MONTGOMERY COUNTY HISTORIC PRESERVATION COMMISSION
STAFF REPORT

Address:	8000 Hampden Lane, Bethesda	Meeting Date:	2/7/2024
Resource:	Contributing Resource (Greenwich Forest Historic District)	Report Date:	1/31/2024
Applicant:	Chuen-Yen Lau & Adam Sherwat	Public Notice:	1/24/2024
Review:	HAWP	Tax Credit:	n/a
Permit No.:	1029531 REVISION	Staff:	Dan Bruechert
Proposal:	Revision to previously approved HAWP for alterations to previously approved garage

PROPOSAL

A002

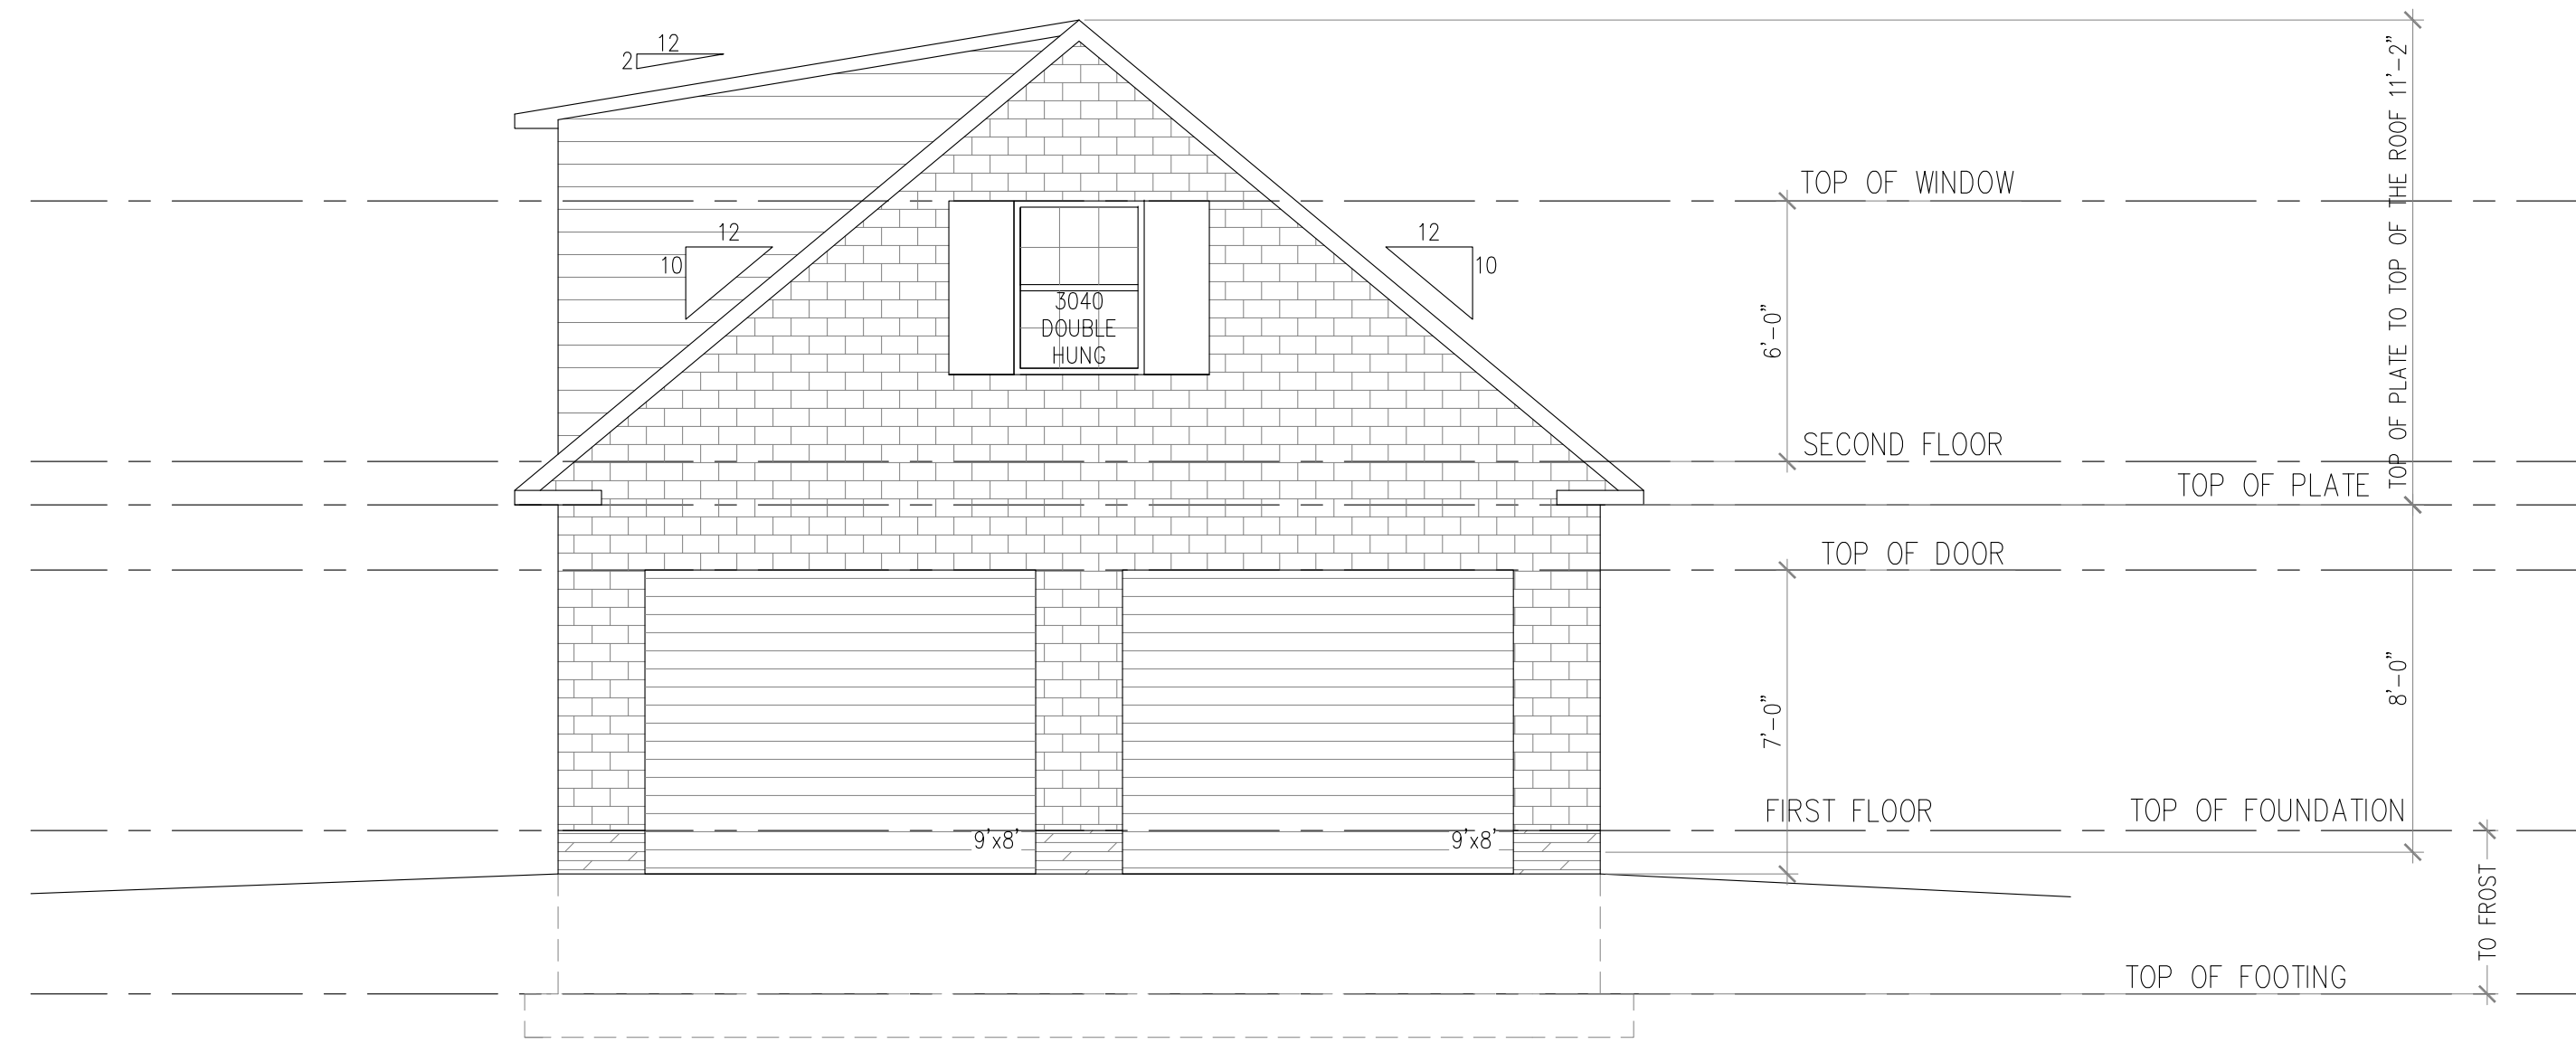
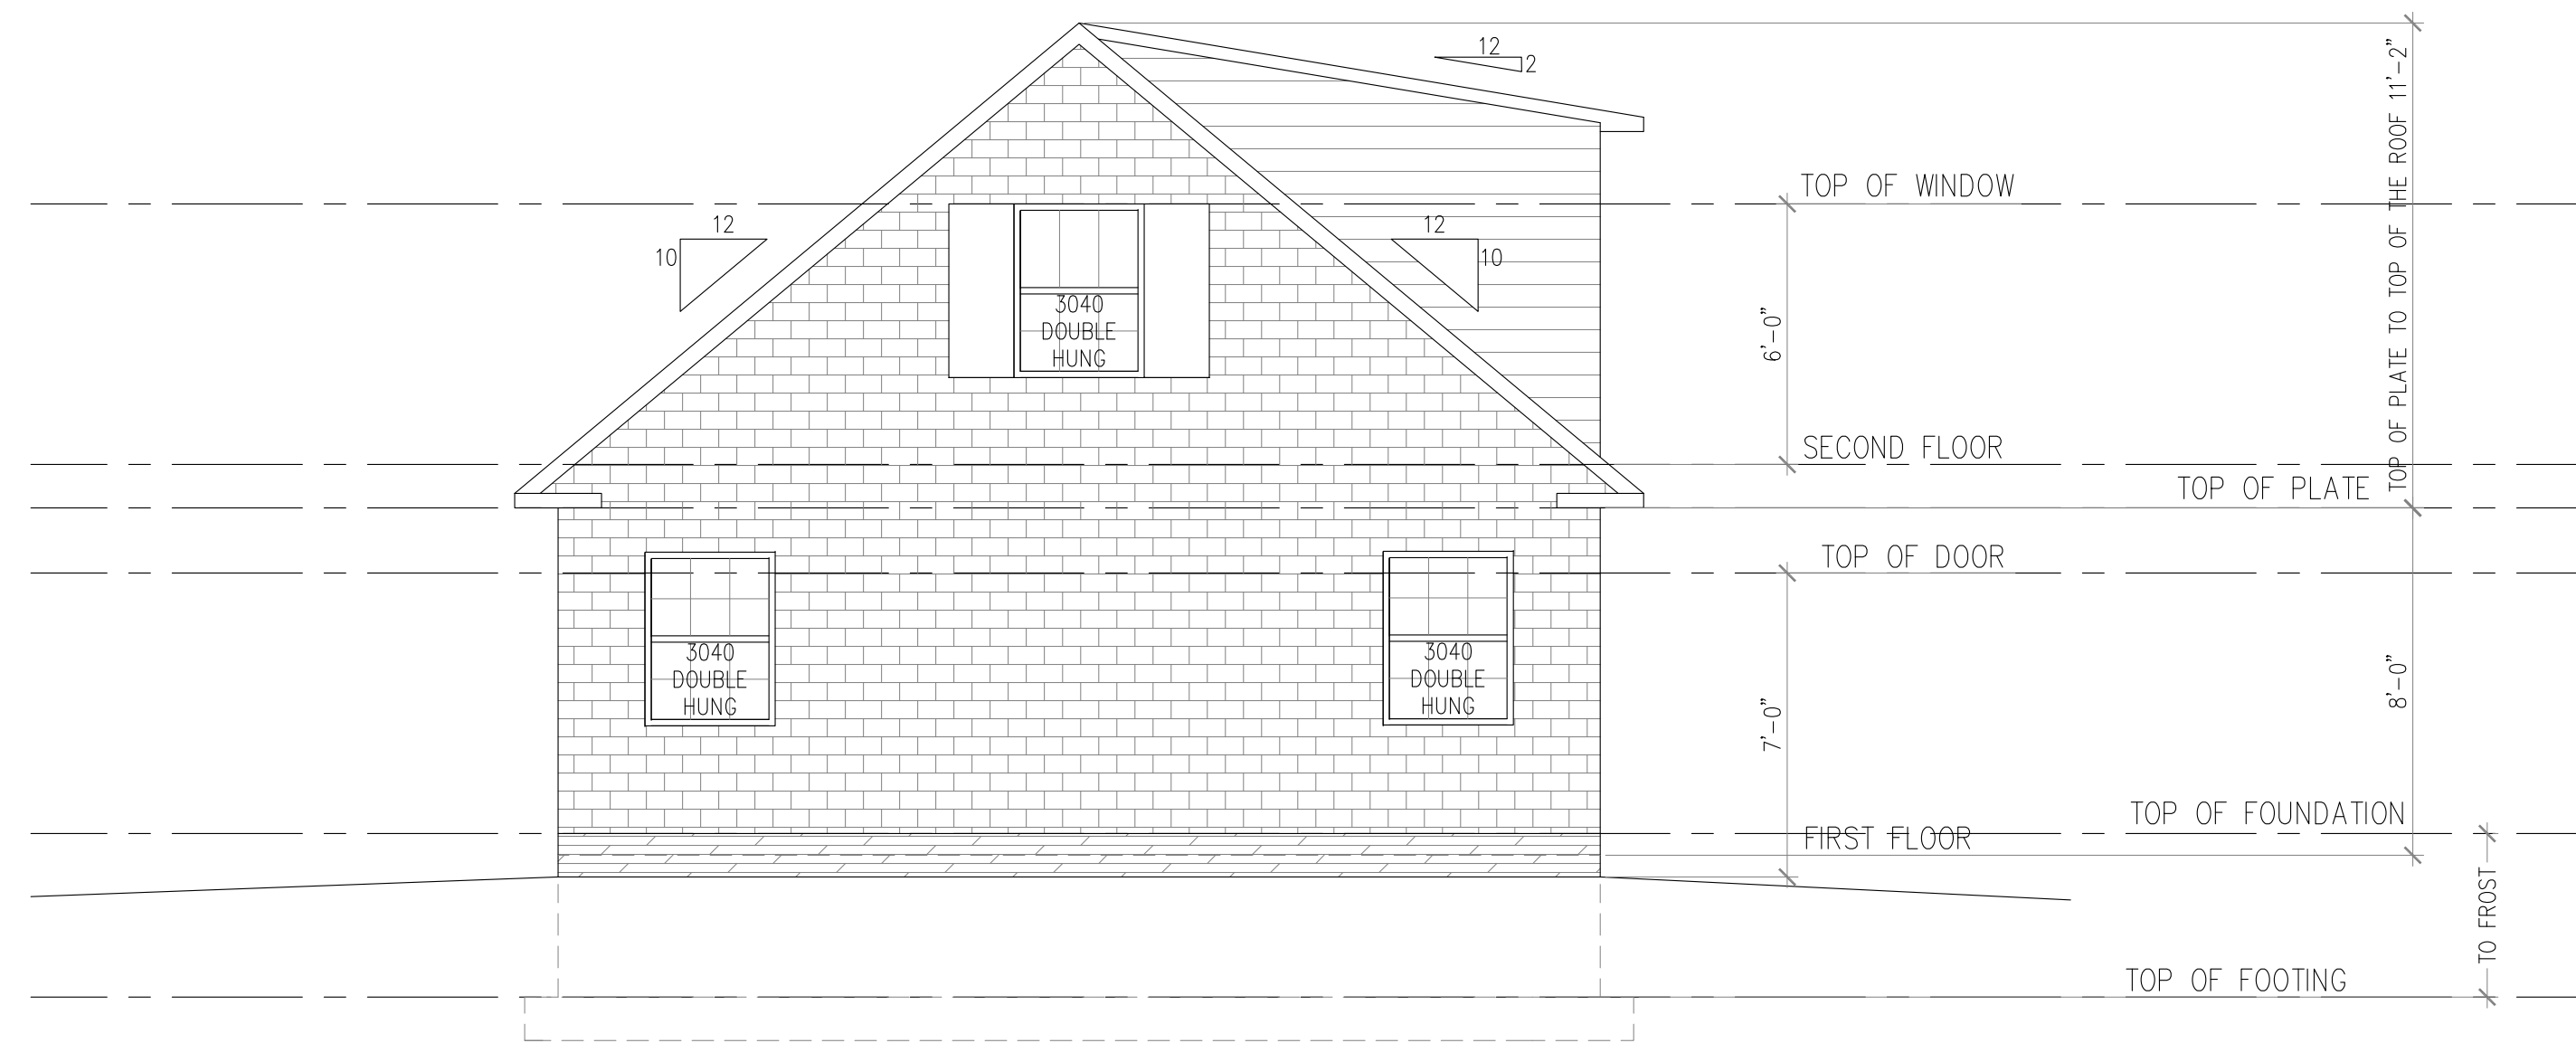
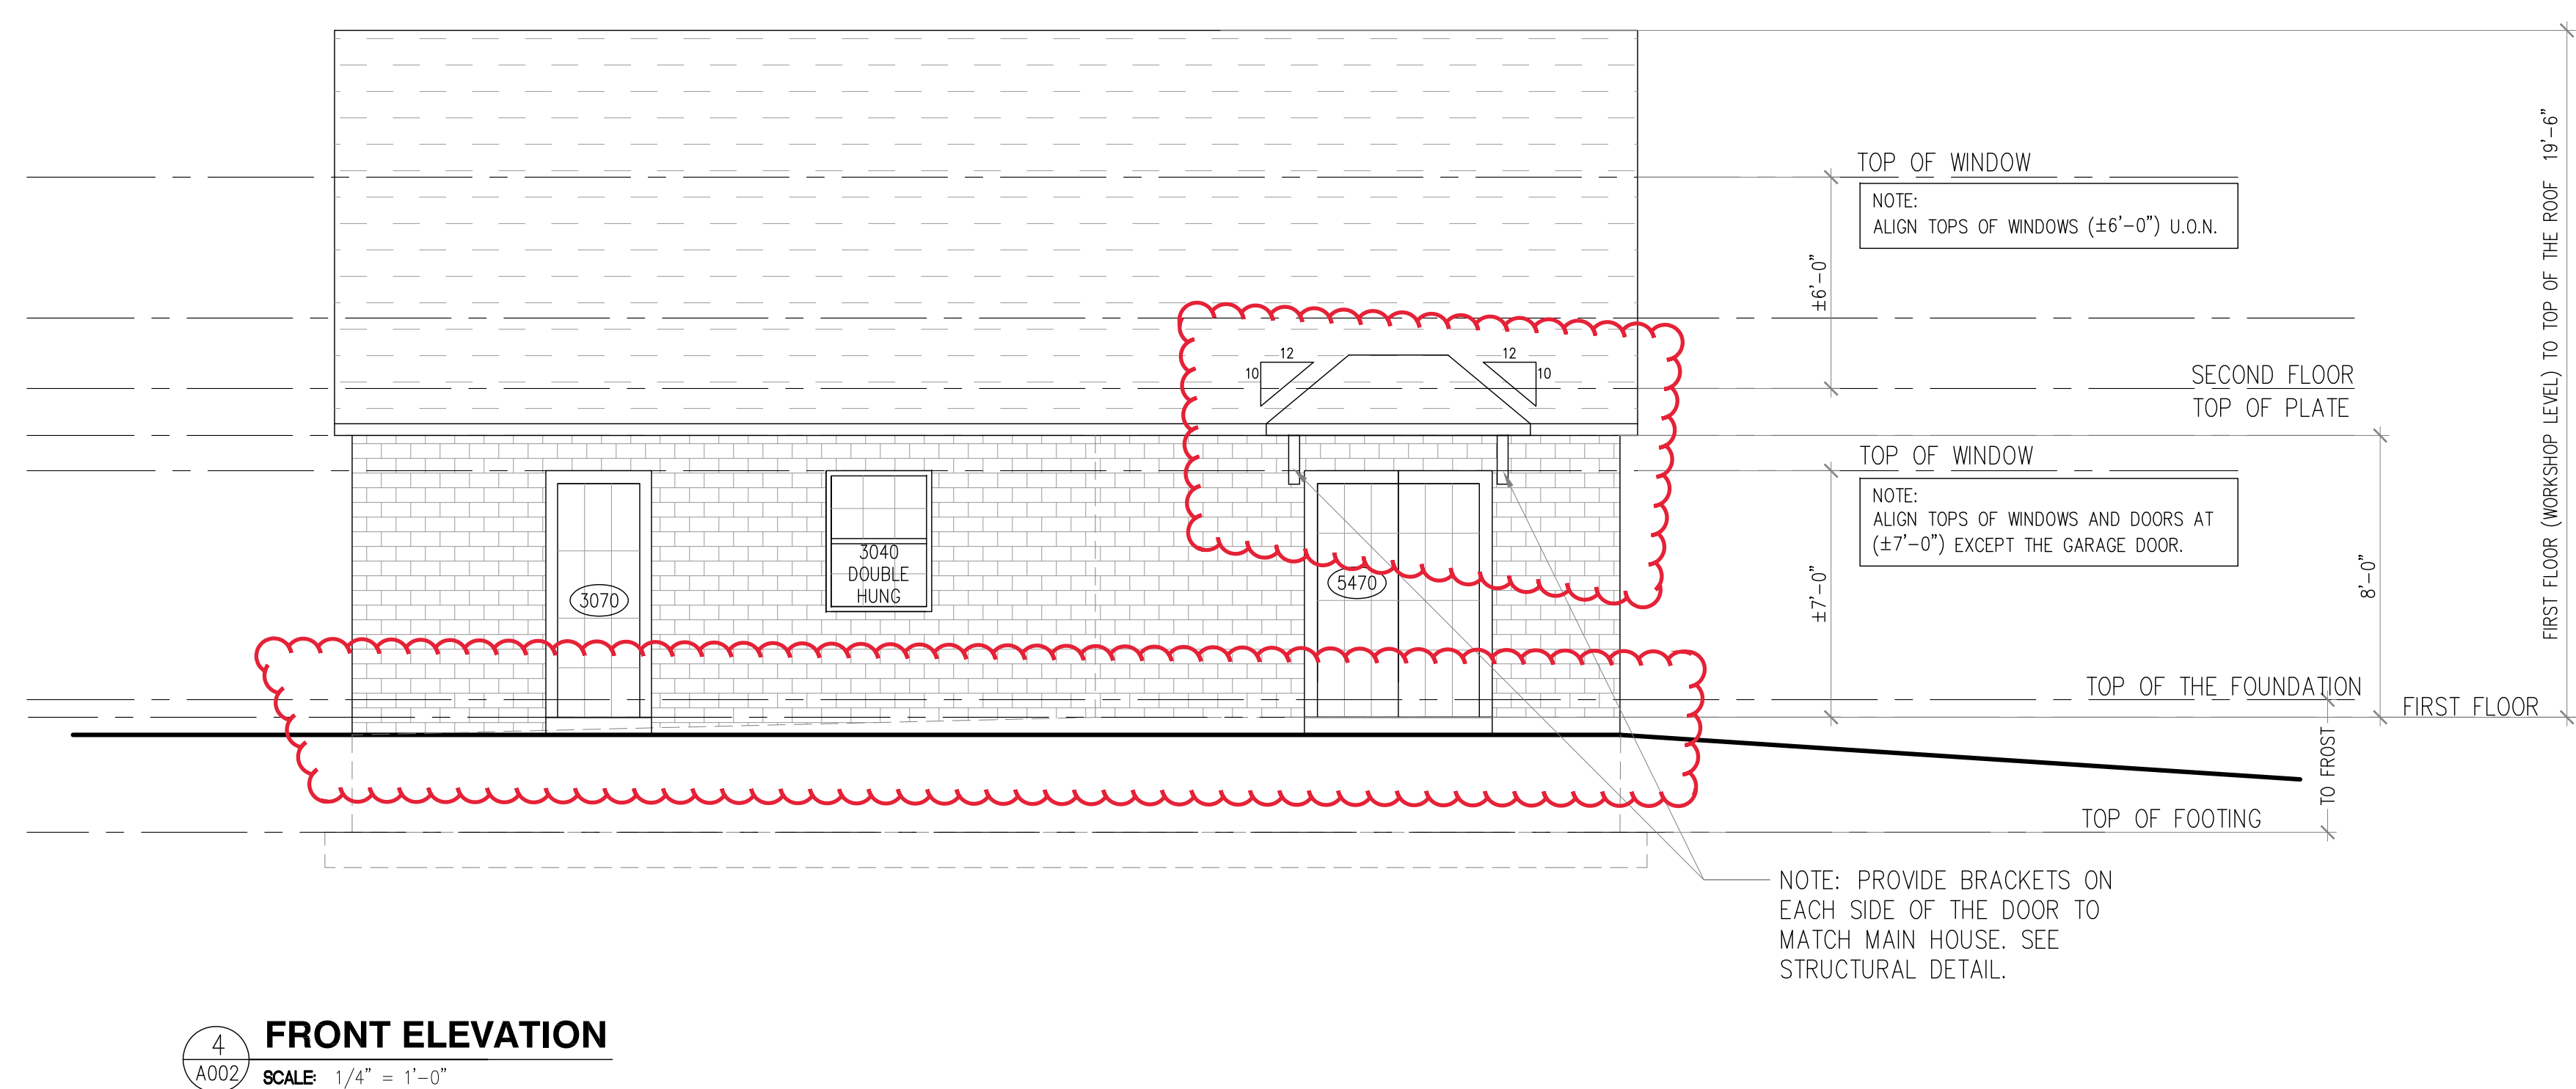
Foundation Material

The approved foundation material was stone to match the house foundation. The revised design has removed the decorative stonework and now proposes to carry the brick exterior to grade. Staff finds this change in materials still satisfies the requirement for ‘high-quality building materials’ as dictated by the *Design Guidelines*. Therefore, Staff recommends the HPC approve the new foundation material under the *Design Guidelines*, 24A-8(b)(2) and (d), and Standards 2, 9, and 10.

Roof Brackets

The HAWP approval showed no roof supports for the small roof above the pair of French doors on the front elevation. The revised design now includes simply detailed wood brackets on either side of pair of doors. Staff finds stylized wood brackets are found throughout the historic district in many of the Tudor Revival houses; and while none are on the subject property, Staff finds this to be a compatible feature and recommends the HPC approve the brackets under the *Design Guidelines*, 24A-8(b)(2) and (d), and

1	Brackets on each side of the door at the workshop shown on the right elevation.
---	---
